Service Bulletin No. 445

MODEL J4500	TYPE Field Change Program	SECTION/GROUP 7-Electrical	DATE Mar. 24, 2017
SUBJECT TRANSMISSION HARNESS ROUTING			
CONDITIONS

Figure 8. Removal of p-clamps from transmission.

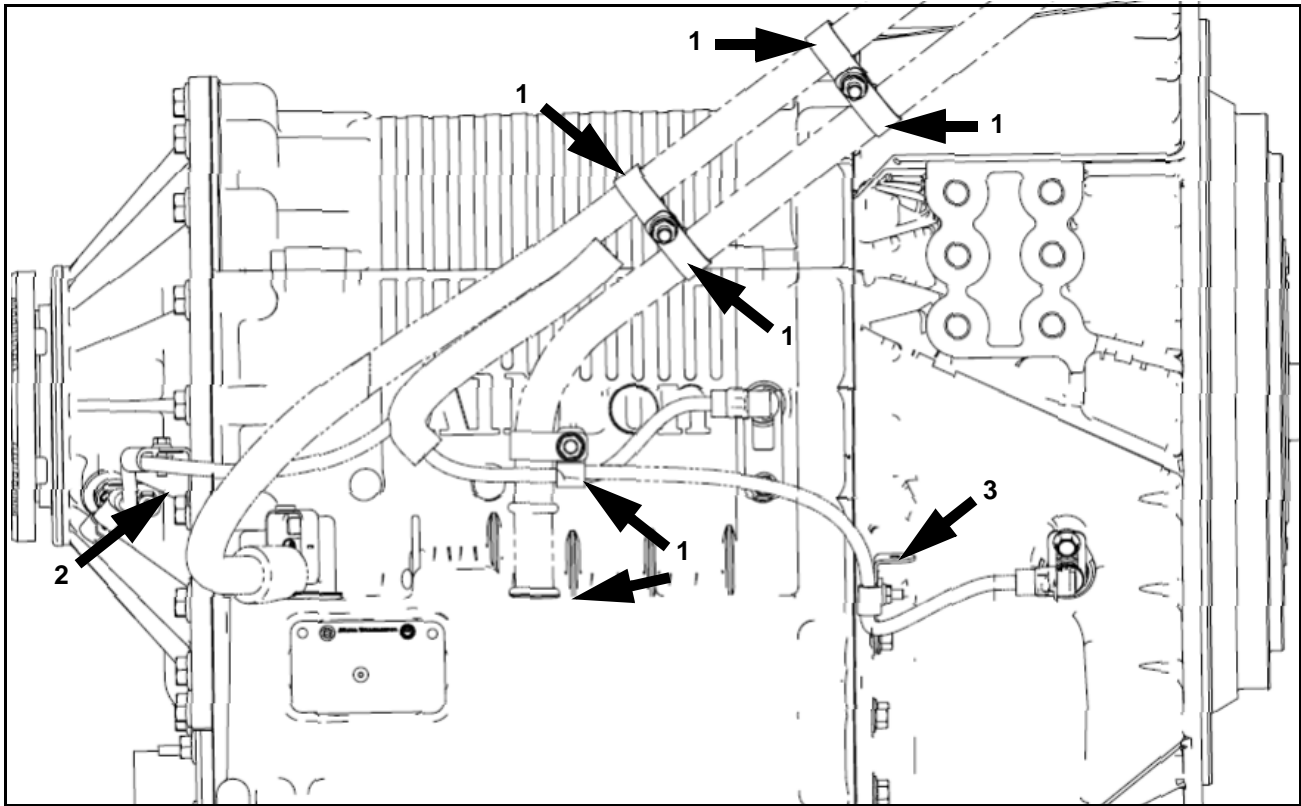
7. Locate the existing p-clamps shown as Item 1 in Figure 8.
8. Remove and discard the eight (8) existing p-clamps shown in Figure 8, as well as the p-clamps on the dipstick.

Item	Figure 8 Description
1	Remove and discard existing eight (8) p-clamps
2	Front bracket location
3	Rear bracket location

Figure 10. Reference photo of front bracket at 30 degree angle and tie base.

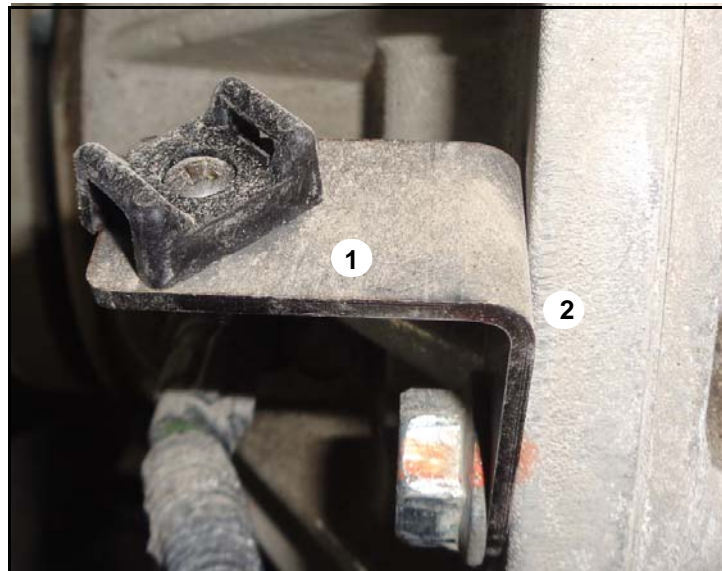
10. Locate the existing front bracket shown as Item 2 in Figure 8.
11. Remove and discard the existing p-clamp and front bracket. Retain the mounting bolt to be used at a later step in this procedure.
12. Using the existing mounting bolt from Step 11 and the new front bracket, p/n 07-08-9052, secure to the transmission finger tight.
13. Orient the front bracket to a 30 degree angle, as shown in Figure 10. Tighten to secure at designated angle. Torque to 74-89 ft-lbs.
14. Orient and install the new tie base, p/n 07-08-4526, using screw, p/n 19-1-586, nut, p/n 19-3-111, spring washer, p/n 19-2-73 and washer, p/n 19-2-19.

Item	Figure 10 Description
1	Front bracket, p/n 07-08-9052
2	Orient and secure front bracket at a 30 degree angle

Figure 11. Reference photo of front bracket at 30 degree angle and tie base.

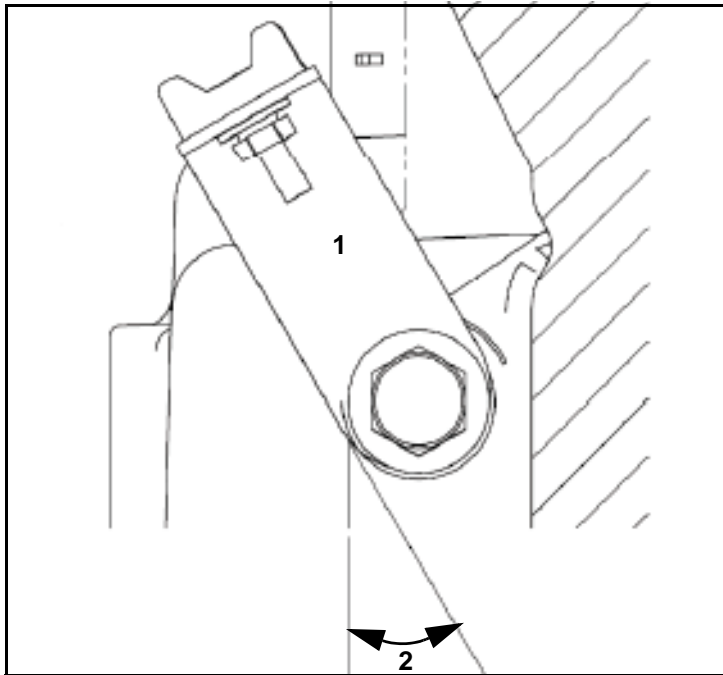
15. .Locate the existing rear bracket shown as Item 3 in Figure 8.
16. Remove and discard the existing p-clamp from the existing rear bracket.
17. Orient the rear bracket to a 30 degree angle, as shown in Figure 11. Tighten to secure at designated angle. Torque to 74-89 ft-lbs.
18. Orient and install the new tie base, p/n 07-08-4526, using screw, p/n 19-1-586, nut, p/n 19-3-111, spring washer, p/n 19-2-73 and washer, p/n 19-2-19.

Item	Figure 11 Description
1	Existing rear bracket
2	Orient and secure bracket at a 30 degree angle

Figure 14. Forward cooling bracket and tie base.

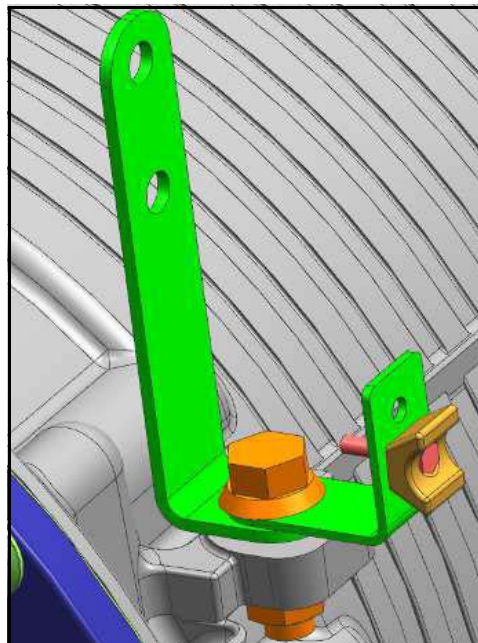
21. Orient and install the existing bracket, screw and nut with the new bracket, p/n 07-08-9052, tie base, p/n 07-08-4525, screw, p/n 19-1-825, washer, p/n 19-02-6035 and nut, p/n 19-3-228 as shown in Figure 14. Tighten to secure.

Figure 16. Push the bracket assembly as far inboard as possible to achieve clearance.

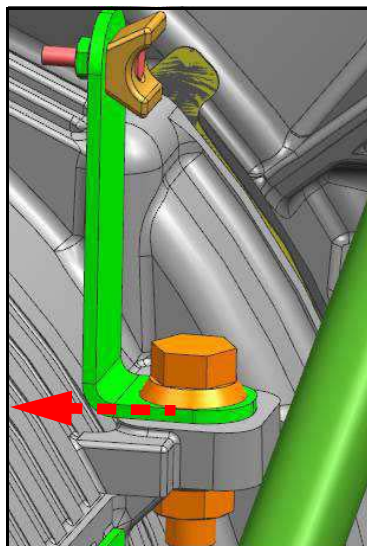
The bracket assembly must be pushed as far inboard towards the transmission as possible to achieve a 0.50 inch clearance between the transmission harness routing and the dipstick.

24. Apply Loctite 242 to the threads of screw, p/n 19-01-1536. Orient the bracket assembly with screw, p/n 19-01-1536 and nut, 19-03-0755 as shown in Figure 16. Push the bracket assembly as far inboard as the hole will allow and tighten to secure.
